File: PO2009

**107275\_SFR**  
**RUAKAKA GROUP DEVELOPMENTS: FURTHER INFORMATION RESPONSE**

Please see our response to your further information request dated 7 February 2025 as follows and as attached.

**Appendix One: Existing Wastewater System Location**

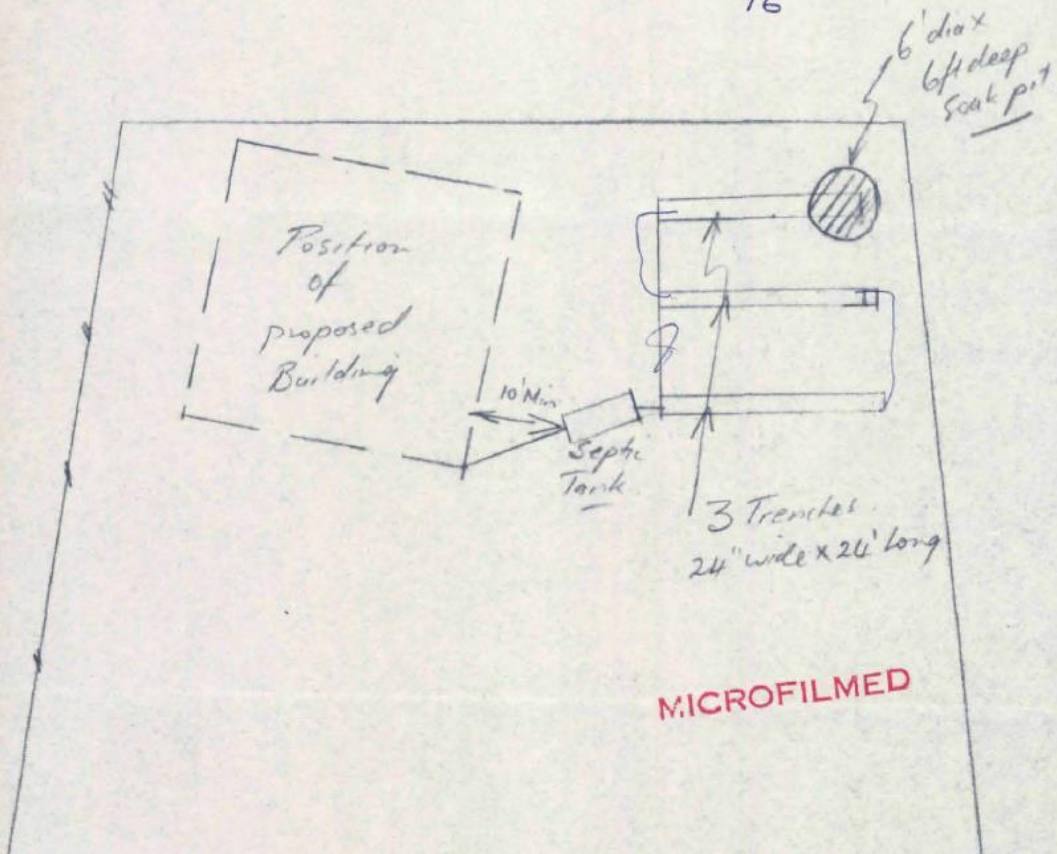
2. *Septic and wastewater systems can sometimes occupy or encroach onto the Sounds Foreshore Reserve (SFR). The application detail does not mention of these types of facilities. Due to the nature of the location, the Department would like to understand if there are any facilities relating to sewage, wastewater or septic systems that occupy*

**RESPONSE:** The existing wastewater system is as per the location plan attached and previously provided. We note this system may be upgraded and we are awaiting further details from the wastewater engineer around the location and technical specifications.
